Addendum No.: 4

York Correctional Institution Central Plant and Piping Distribution

BI – JA – 465

The following clarifications are applicable to drawings and specifications for the project referenced above.

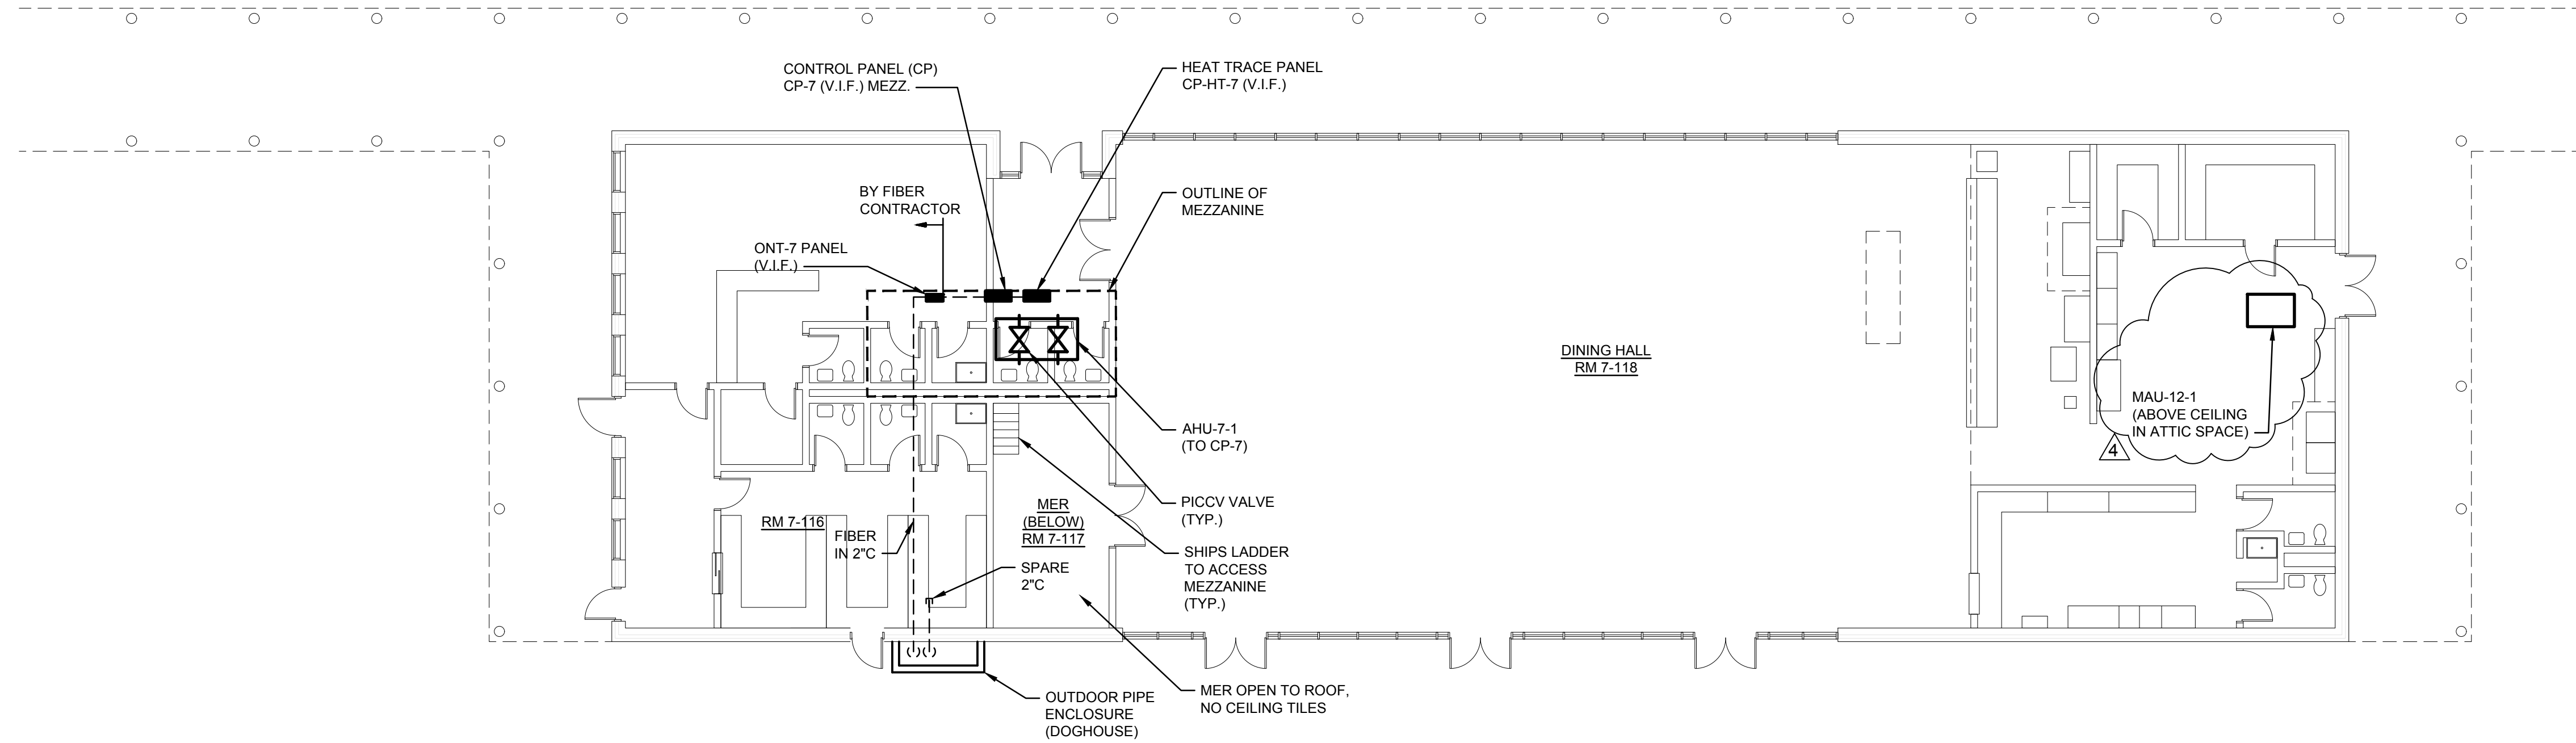
Drawing M757 Building 7 Equipment Layout and Controls

**REPLACE** the entire drawing with the attached.

**UPDATED** drawing to show location of makeup air unit in response to pre-bid question Q127

A127: Refer to contract drawing M766, Addendum 4 for location of MAU-12-1. NOTE; building 7 is similar to building 12. Also, refer to contract drawing M757 for location of MAU-7-1.

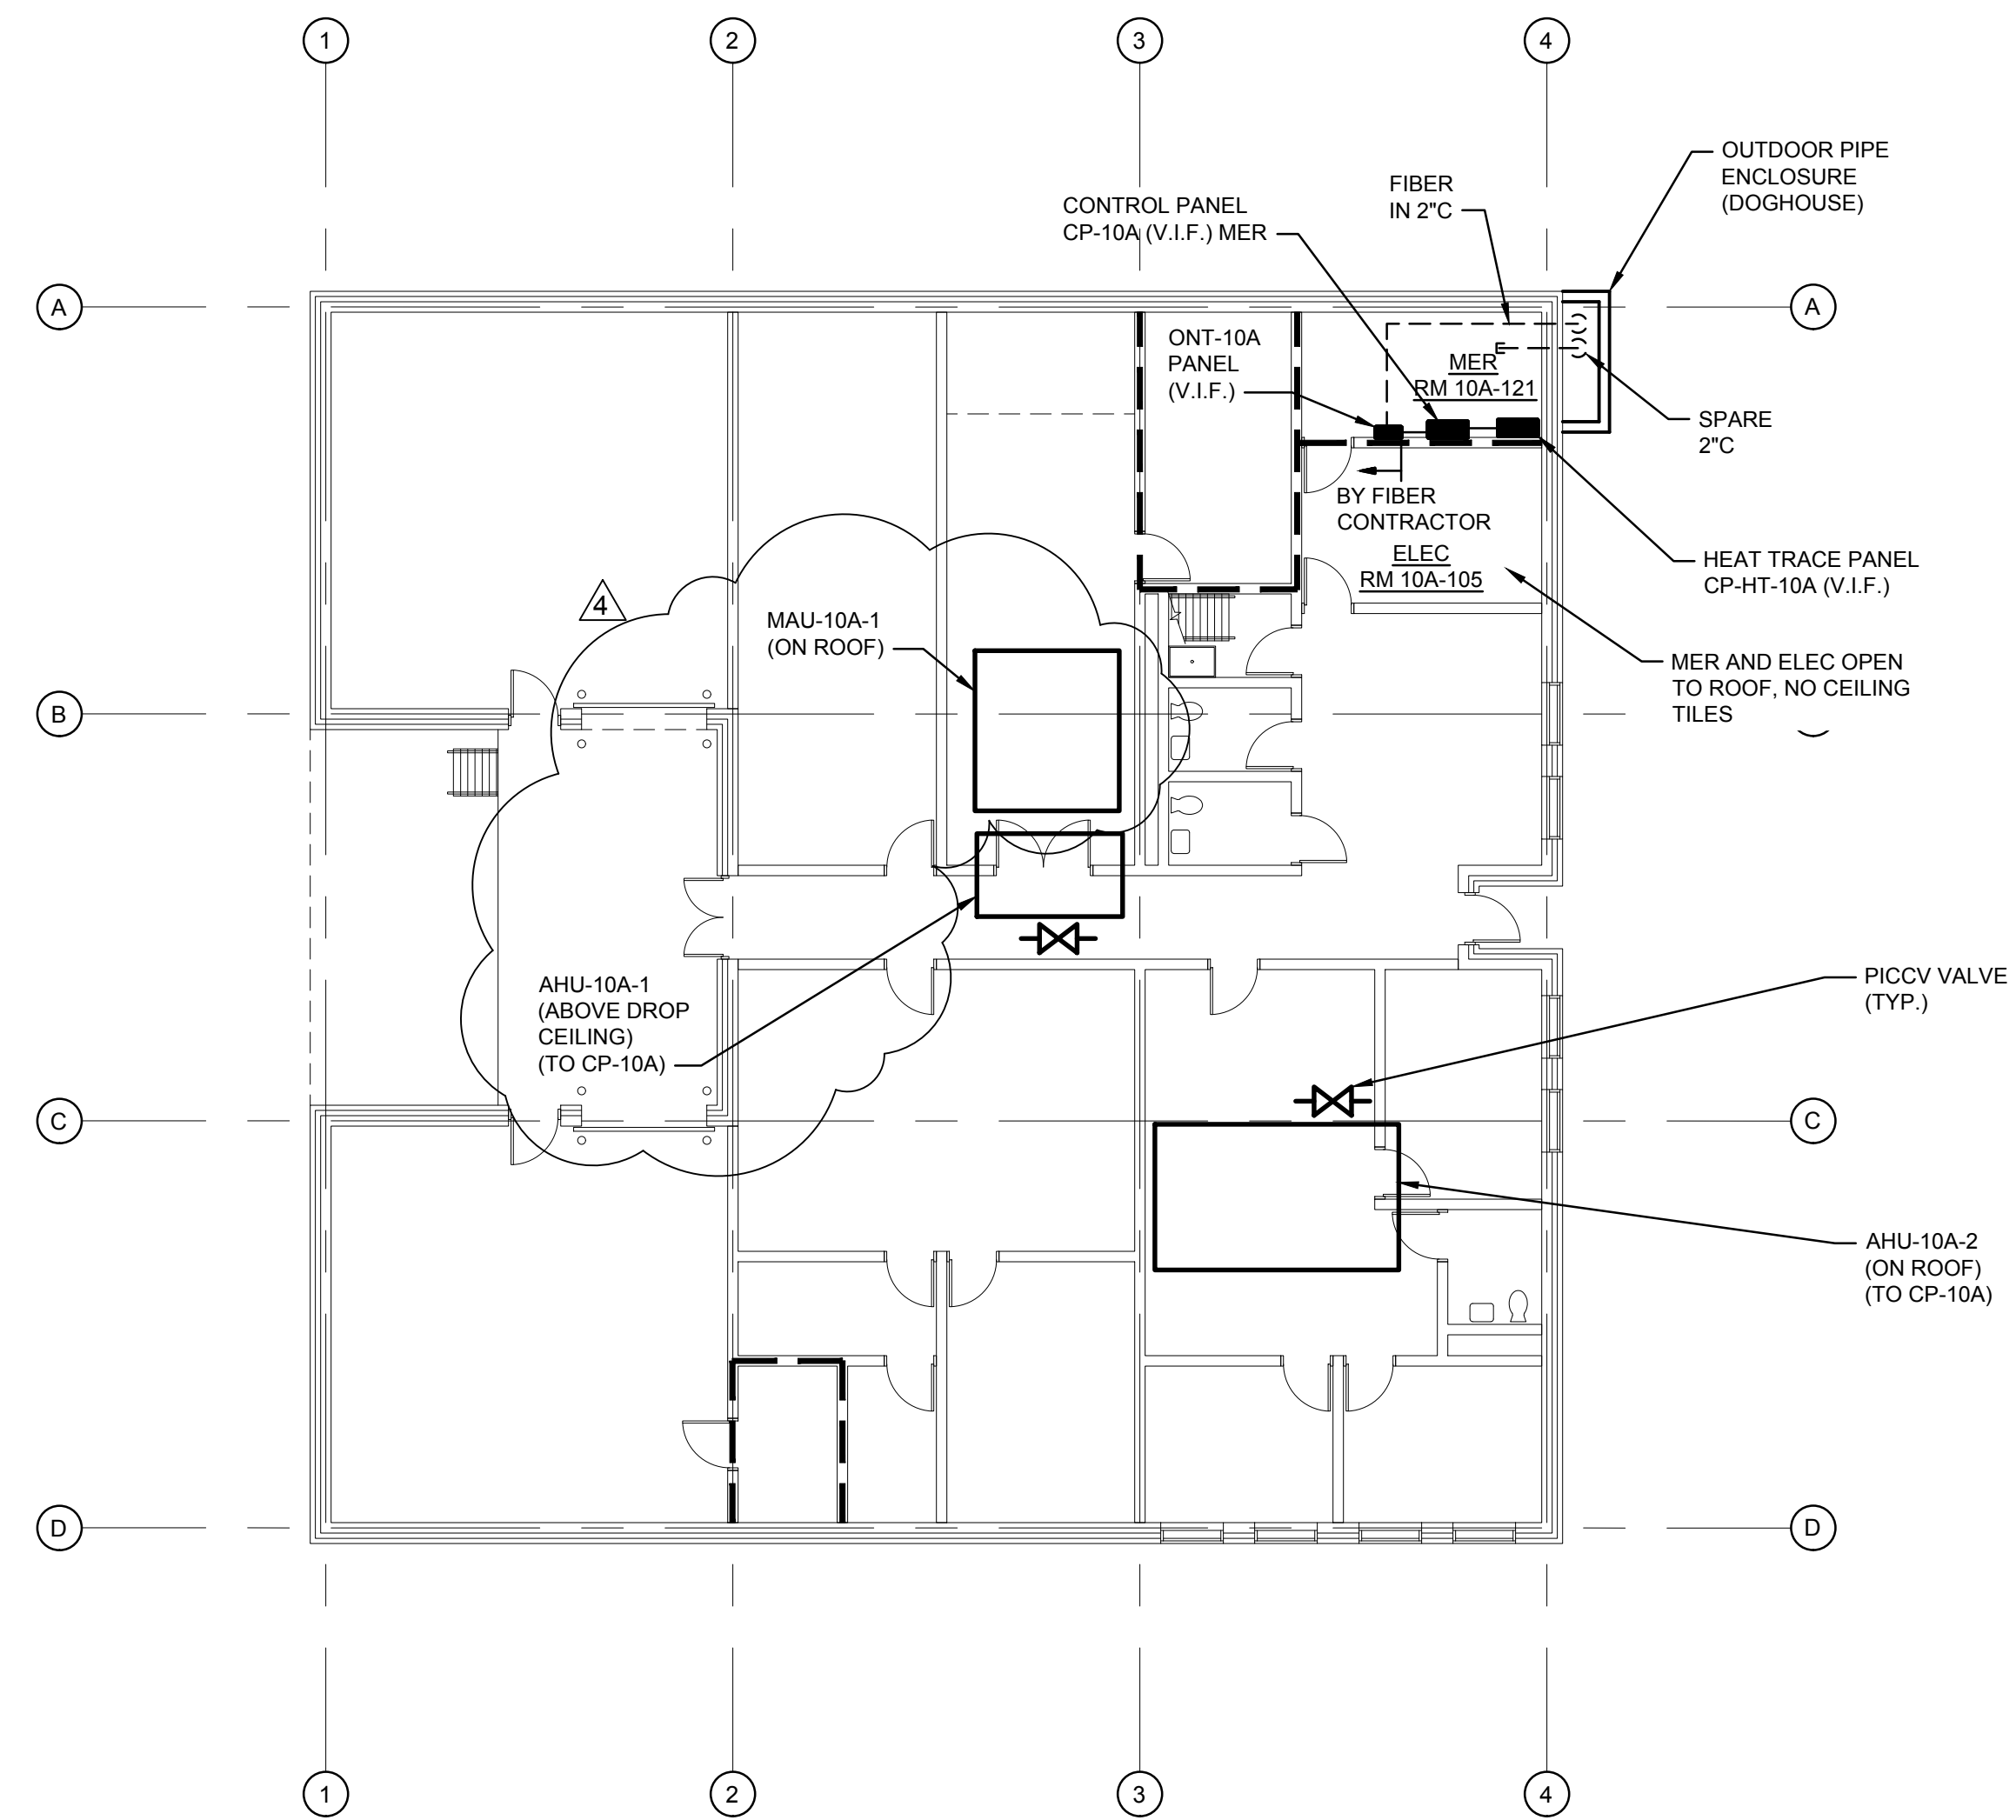
Drawing M764 Building 10A Equipment Layout and Controls

**REPLACE** the entire drawing with the attached.

**UPDATED** drawing to show location of makeup air unit in response to pre-bid question Q126

A126: Refer to contract drawing M764, Addendum 4 for location of MAU-10A-1.

**1 BUILDING 12 MEZZANINE INSTALLATION**

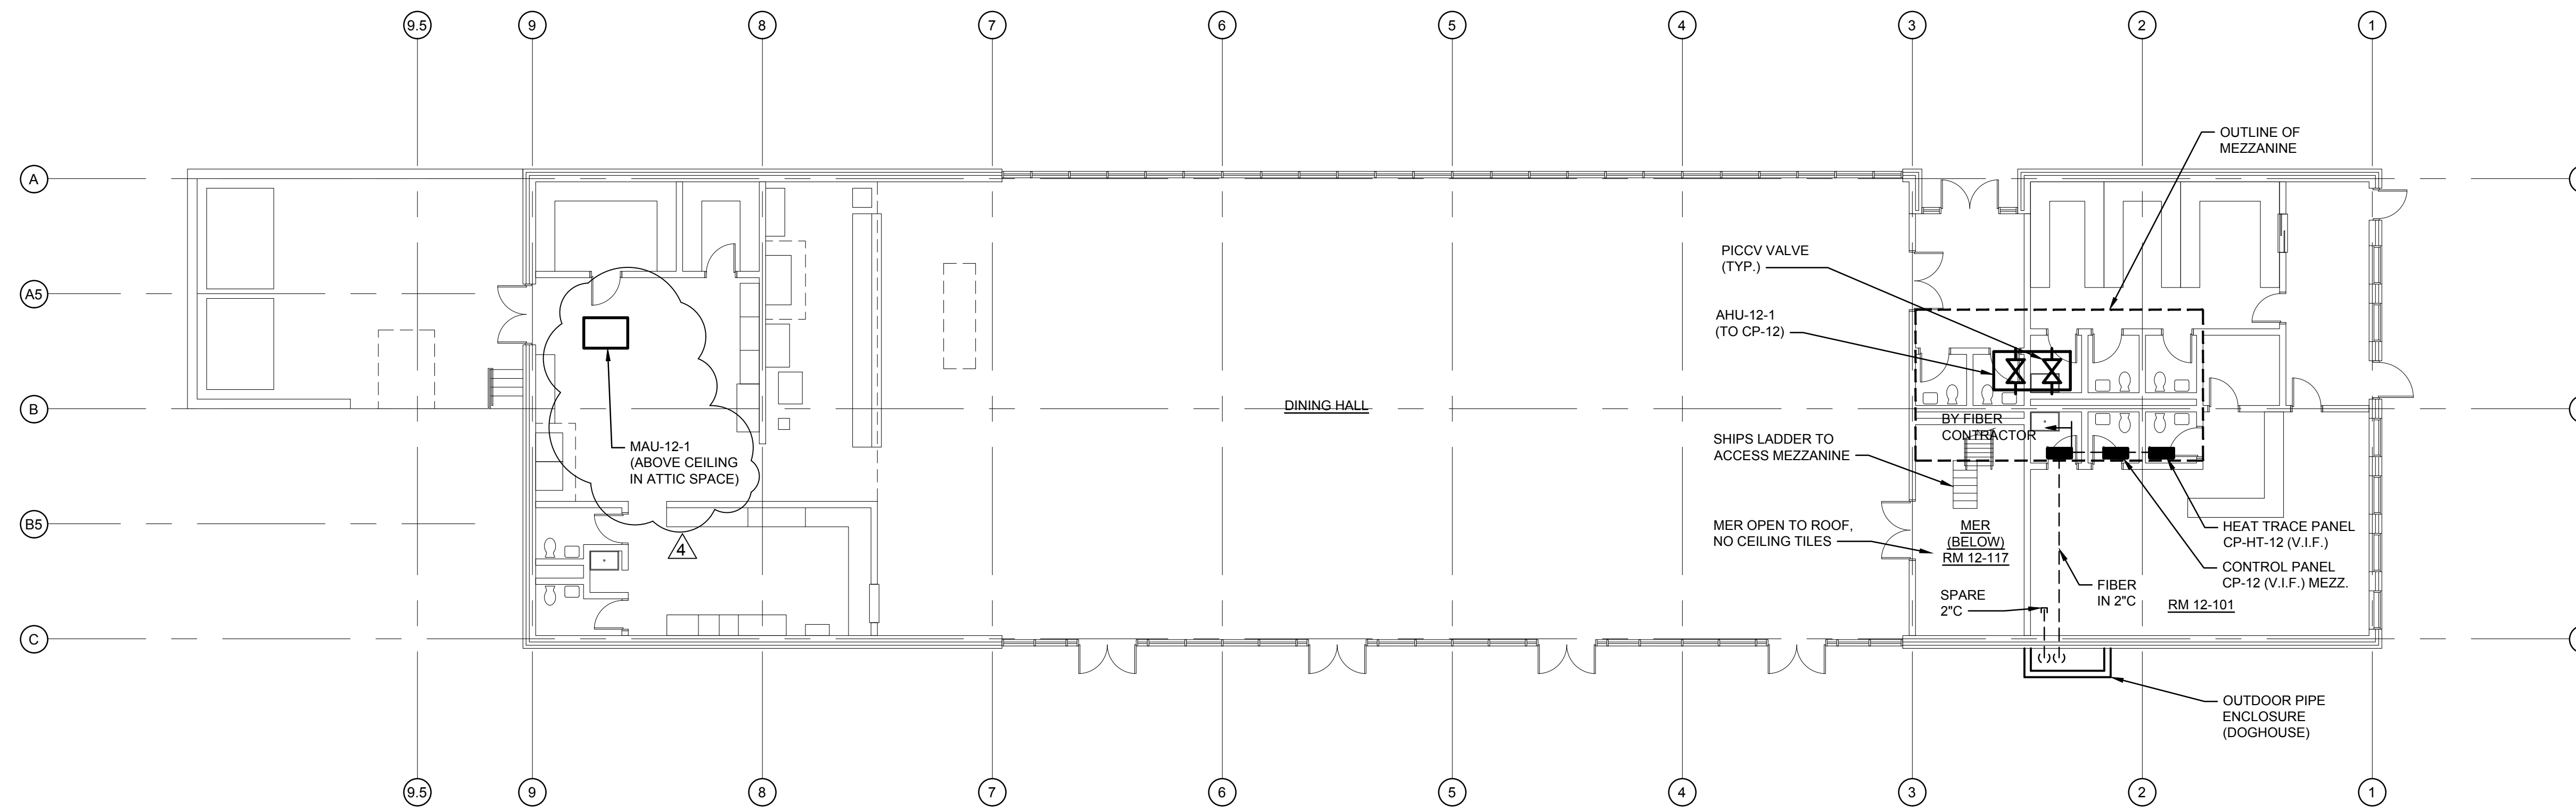
Drawing M766 Building 12 Equipment Layout and Controls

**REPLACE** the entire drawing with the attached.

**UPDATED** drawing to show location of makeup air unit in response to pre-bid question Q127
